Access Compliance Report Public Rights-of-Way (Curb Ramps)

Main Street: OLD_RANCH_RD		Cross Street: FAIRMONT_BLV		Location:	NW
ADA ID: RPAT211115111027	Ramp Type: Type 4 - Parallel	Initial Pass/Fail: Fail	Overall Compliance: No	Severity Score:	16
Codes/Mitigation Info/Possible Solution			Field Measurements/Component Compliance

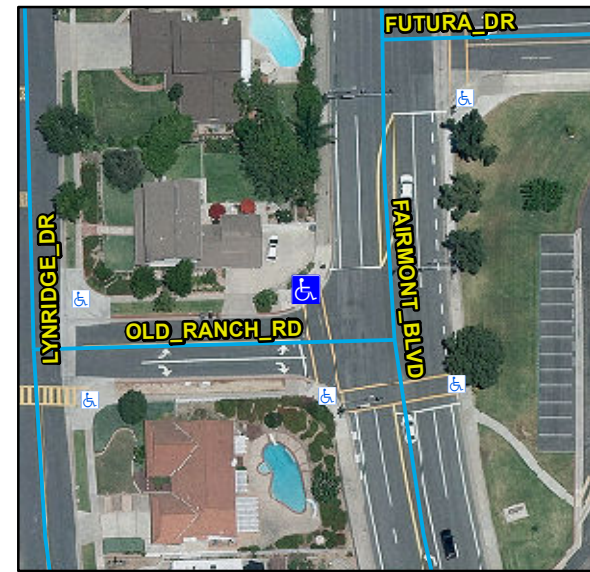
Compliance	Description	Data	Compliance	Description	Data
N/A	Ramp Length LT (in)	90	N/A	Ramp Length RT (in)	112
Yes	Ramp Width LT (in)	113	Yes	Ramp Width RT (in)	104
Yes	Ramp Run Slope LT (%)	1.2	No	Ramp Run Slope RT (%)	11.3
No	Ramp Cross Slope LT (%)	2.6	Yes	Ramp Cross Slope RT (%)	0.7
N/A	Landing Present	N/A	N/A	DWS Provided	N/A
N/A	Landing Length (in)	N/A	N/A	DWS Contrast	N/A
N/A	Landing Width (in)	N/A	N/A	DWS Length (in)	N/A
N/A	Landing Run Slope (%)	N/A	N/A	DWS Full Width	N/A
N/A	Landing Cross Slope (%)	N/A		DWS Offset Type	N/A
N/A	Landing Movement Obstructed?	N/A	N/A	DWS Offset Left (in)	N/A
	Landing Movement Type	N/A	N/A	DWS Offset Right (in)	N/A
N/A	Landing Shared	N/A			
N/A	Clear Space	Yes			
N/A	Clear Space To Crosswalk (in)	N/A			
N/A	Marked Crosswalk 1	Yes	N/A	Marked Crosswalk 2	No
	Crossing 1 Direction	E		Crossing 2 Direction	S
	Marked Crosswalk 1 Width (in)	120		Marked Crosswalk 2 Width (in)	N/A

Remove & Replace Curb Ramp With Two New Directional Ramps or Equivalent.
